DELAWARE DEPARTMENT OF TRANSPORTATION	ADDENDUMS / REVISIONS	NOT TO SCALE	SR1 / I-95 INTERCHANGE	CONTRACT 28-090-03	BRIDGE NO.	TYPICAL SECTIONS	SHEET NO. 10
	ADDENDUM NO. 3 CHANGED ITEM NO., 02/18/2011, RLS			COUNTY NEW CASTLE	DESIGNED BY:		TOTAL SHTS. 803
					CHECKED BY:

DELAWARE DEPARTMENT OF TRANSPORTATION	ADDENDUMS / REVISIONS ADDENDUM NO. 3 CHANGED ITEM NO., ADDED O.H. SIGN REMOVAL, 02/18/2011 RLS	SCALE 0 50 100 150 FEET	SR1 / I-95 INTERCHANGE	CONTRACT 28-090-03 COUNTY NEW CASTLE	BRIDGE NO. DESIGNED BY: CHECKED BY:	CONSTRUCTION PLAN

DELAWARE DEPARTMENT OF TRANSPORTATION	ADDENDUMS / REVISIONS: ADDENDUM NO. 3 VOIDED SHEET; MODIFIED ITMS DESIGN SEE SHEET 711A, 02/18/2011, JCR	SCALE 0 50 100 150 FEET	SR1 / I-95 INTERCHANGE	CONTRACT 28-090-03; COUNTY NEW CASTLE; BRIDGE NO.; DESIGNED BY:; CHECKED BY:	SIGNING, STRIPING & CONDUIT PLAN; SSC-1; SHEET NO. 711; TOTAL SHTS. 803

ADDENDUMS / REVISIONS	
ADDENDUM NO. 3 THIS SHEET 721A	
REPLACES VOIDED SHEET 721	
02/18/2011, JCR

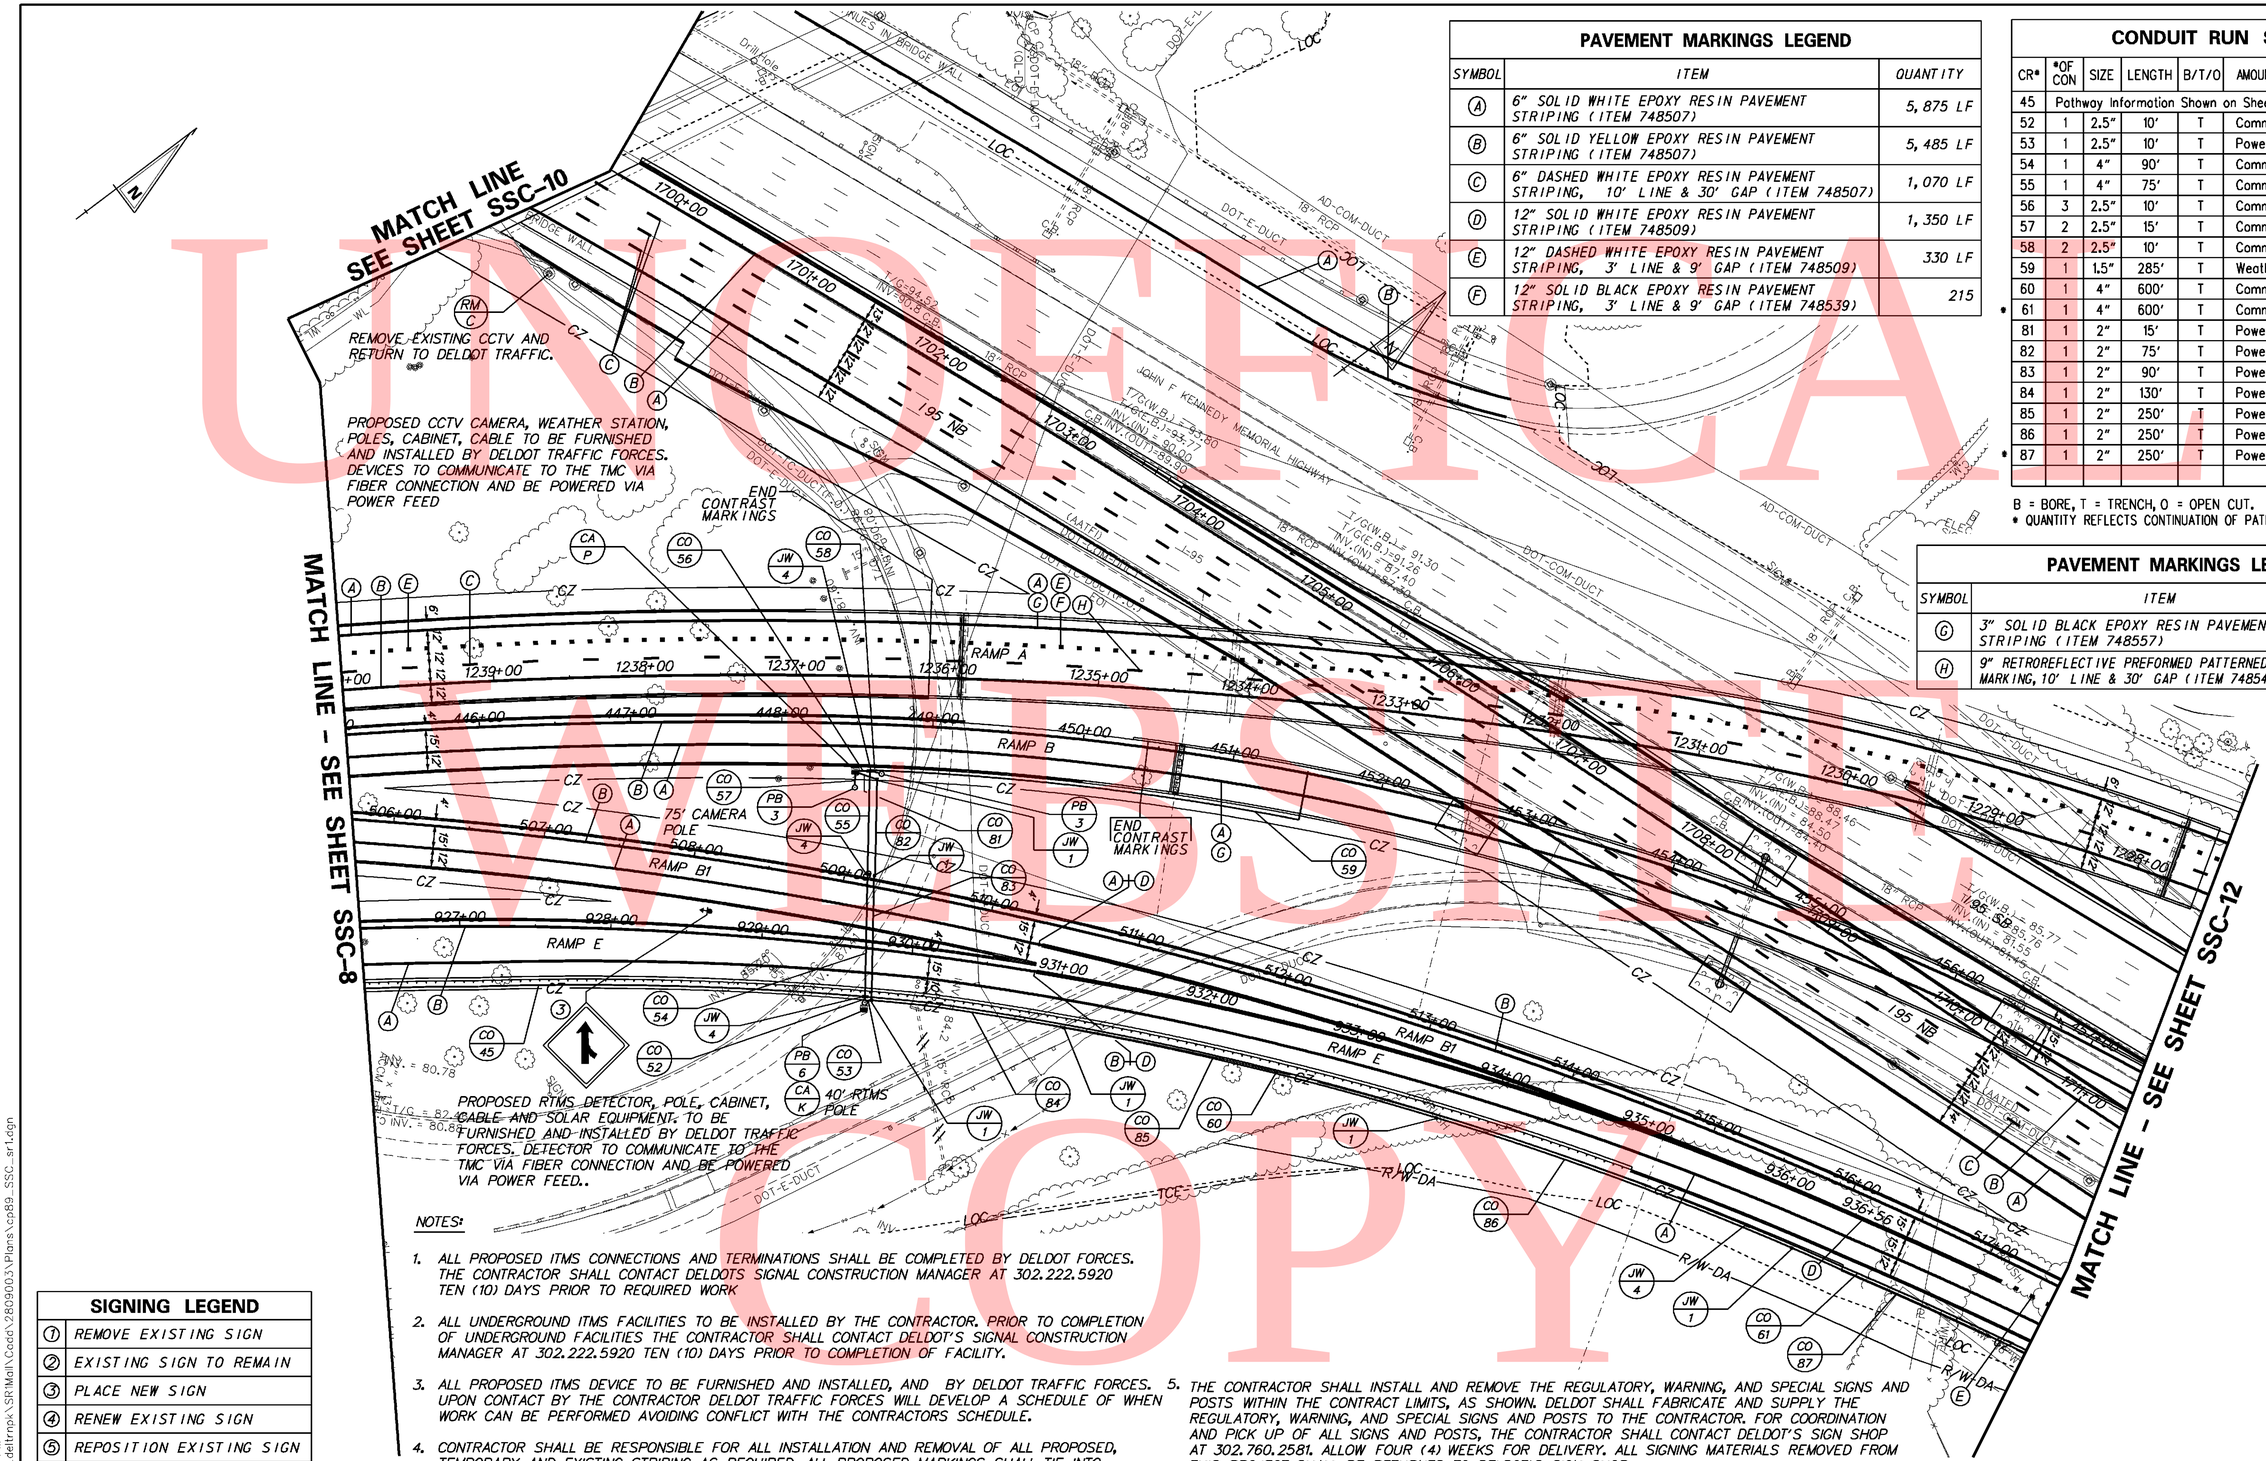
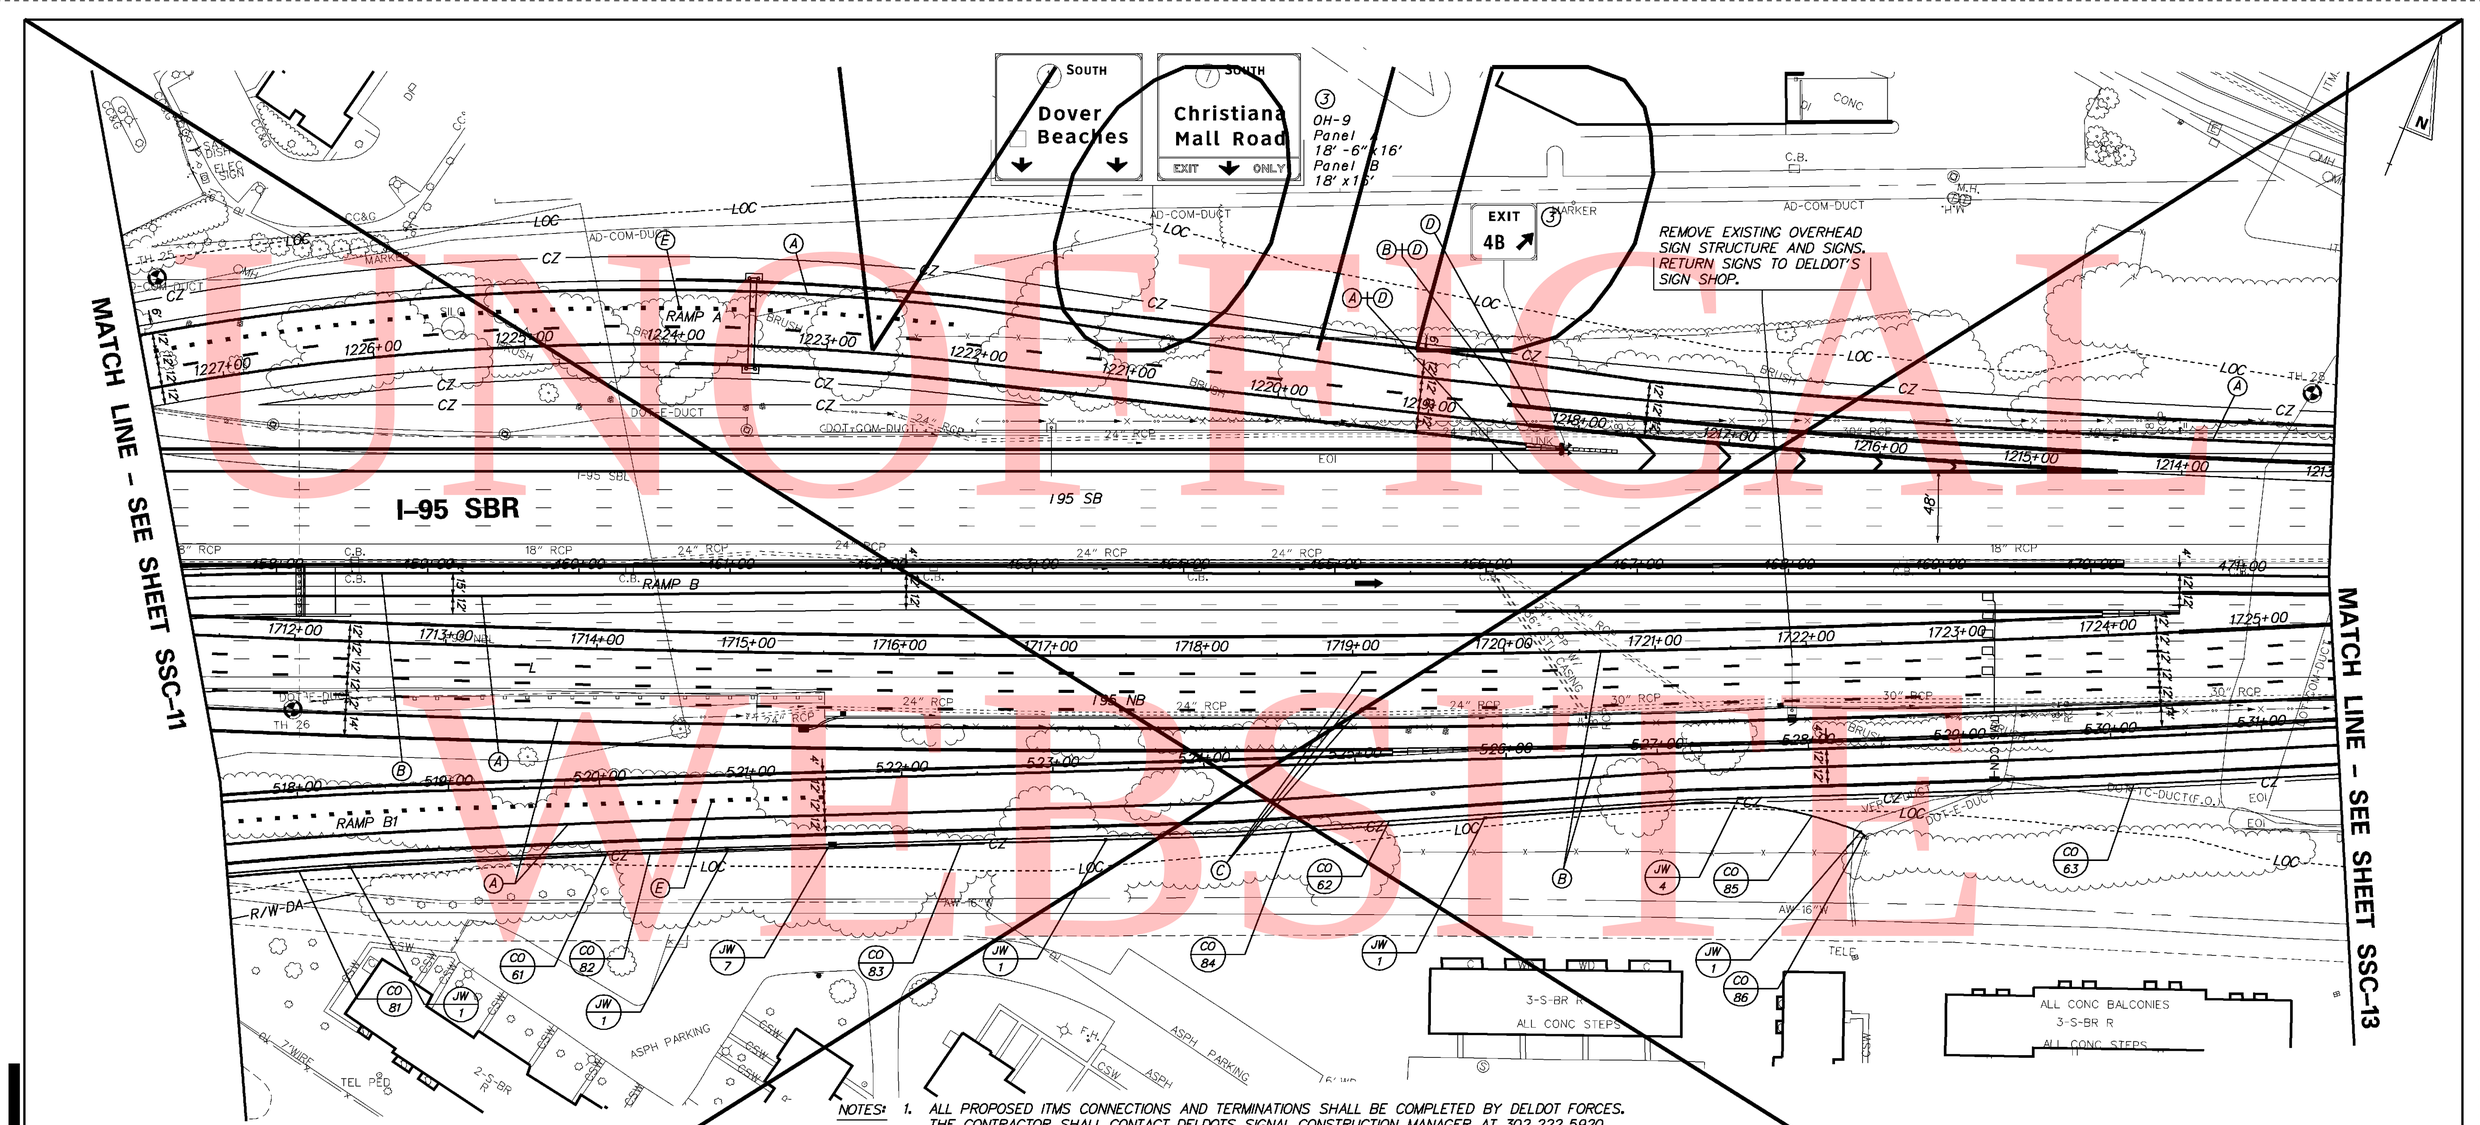
ADDENDUMS / REVISIONS	
ADDENDUM NO. 1 VOIDED SHEET	
MODIFIED ITMS DESIGN SEE SHEET 721A,	
02/18/2011, JCR

CR*	#OF CON	SIZE	LENGTH	B/T/O	AMOUNT AND TYPE OF CABLE/ WIRE
45	Pathway Information Shown on Sheet SSC-8				
52	1	2.5"	10'	T	Comm. Cable
53	1	2.5"	10'	T	Power
54	1	4"	90'	T	Comm. Cable
55	1	4"	75'	T	Comm. Cable
56	3	2.5"	10'	T	Comm. Cable
57	2	2.5"	15'	T	Comm. Cable
58	2	2.5"	10'	T	Comm. Cable
59	1	1.5"	285'	T	Weather Sensor
60	1	4"	600'	T	Comm. Cable
* 61	1	4"	600'	T	Comm. Cable
81	1	2"	15'	T	Power
82	1	2"	75'	T	Power
83	1	2"	90'	T	Power
84	1	2"	130'	T	Power
85	1	2"	250'	T	Power
86	1	2"	250'	T	Power
* 87	1	2"	250'	T	Power

ADDENDUMS / REVISIONS	
ADDENDUM NO. 3 THIS SHEET 723A	
REPLACES VOIDED SHEET 723	
02/18/2011, JCR

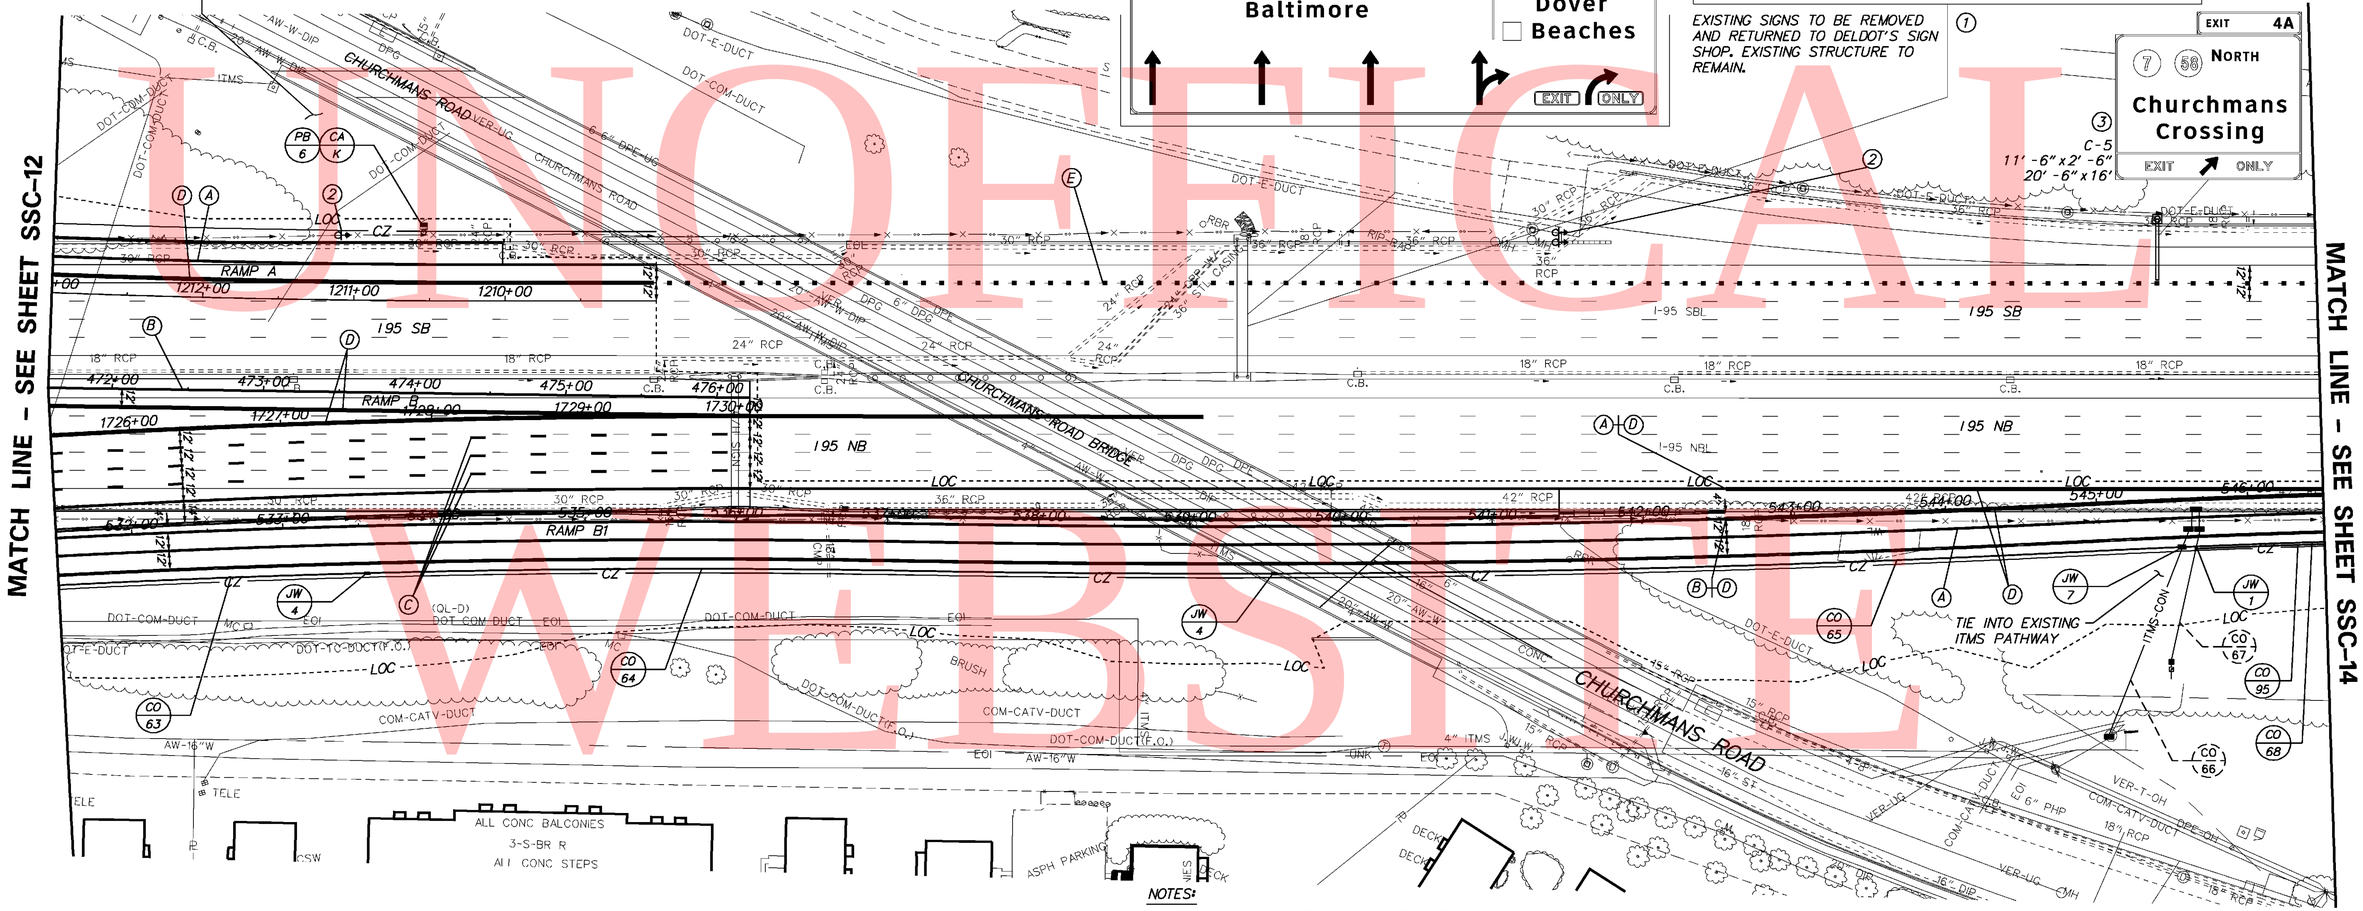
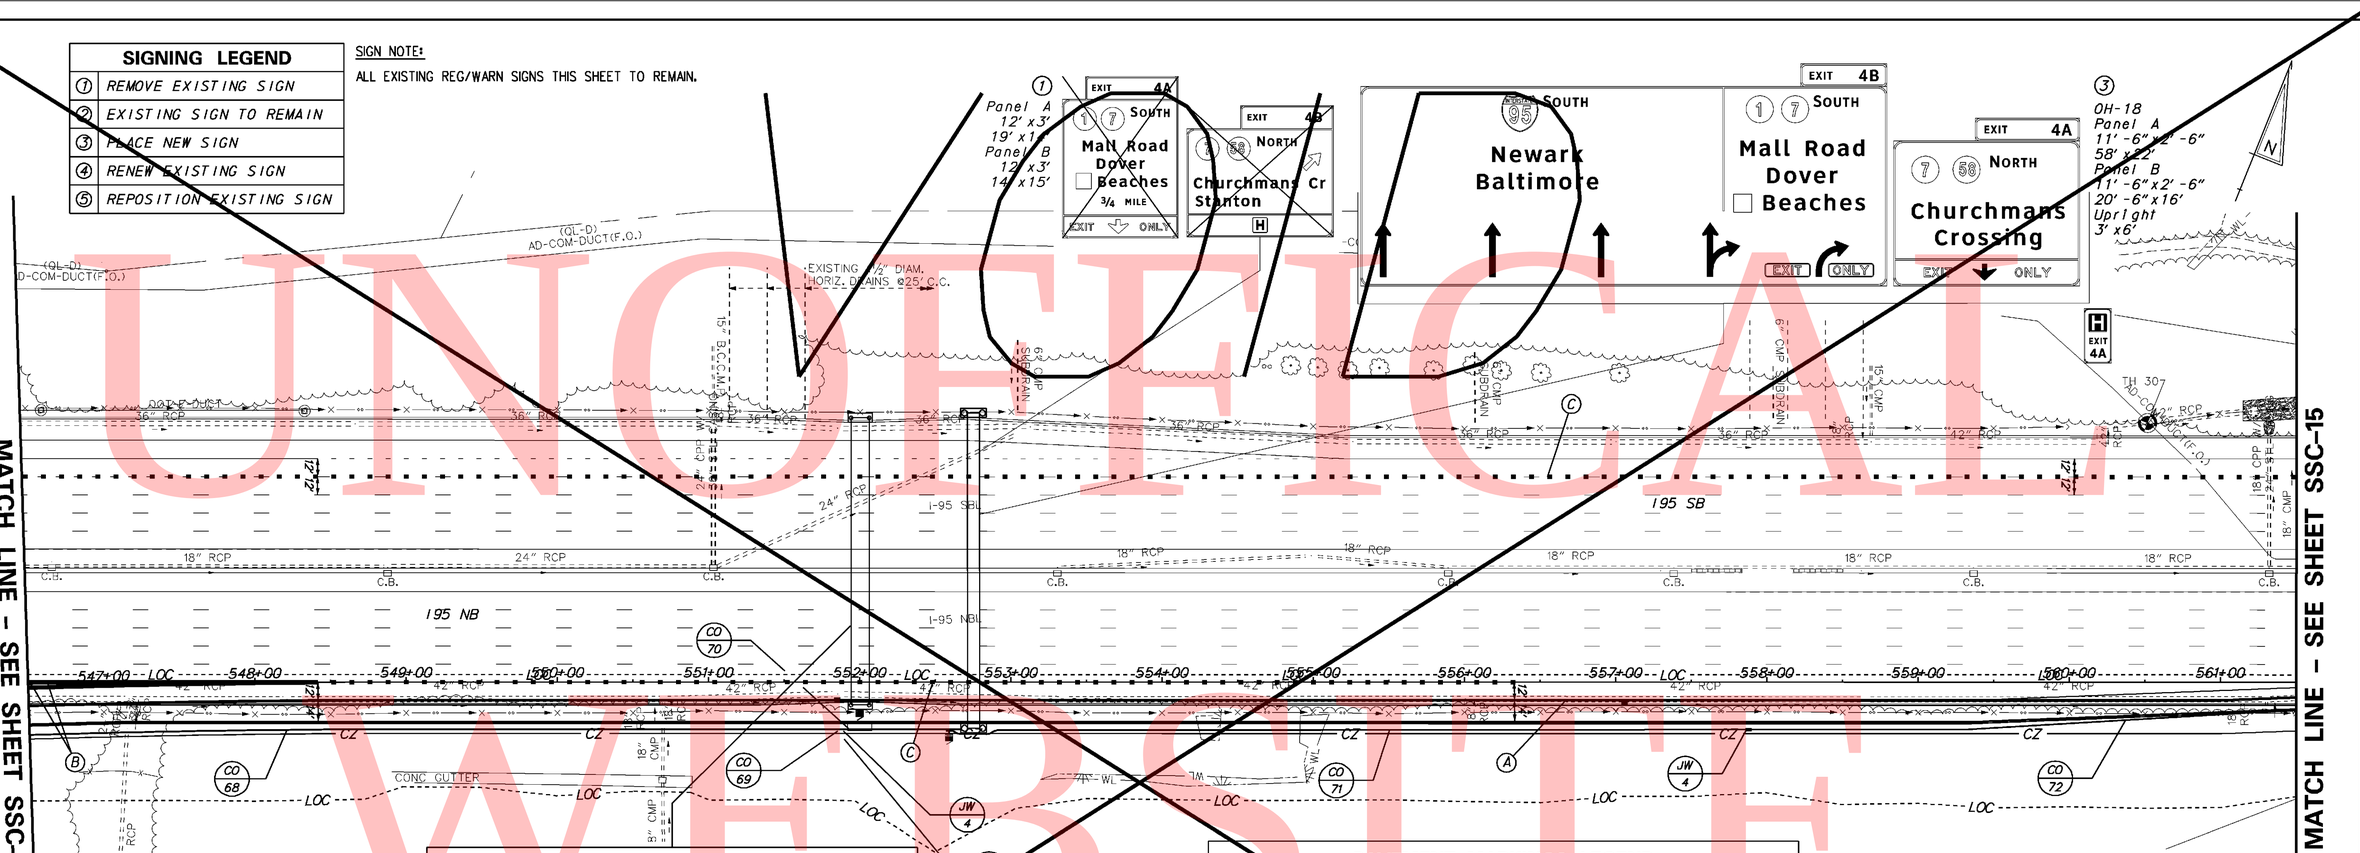
ADDENDUMS / REVISIONS
ADDENDUM NO. 3 , VOIDED SHEET 723
MODIFIED ITMS DESIGN SEE SHEET 723A,
2/17/11 JCR

CR*	#OF CON	SIZE	LENGTH	B/T/O	AMOUNT AND TYPE OF CABLE/ WIRE
	63	Pathway Information Shown on Sheet SSC-12				
	64	1	4″	600′	T	Comm. Cable
	65	1	4″	600′	T	Comm. Cable
*	66	1	4″	150′	T	Comm. Cable
*	67	1	4″	90′	T	Comm. Cable
**	68	1	4″	625′	T	Comm. Cable
**	95	1	2″	250′	T	Power
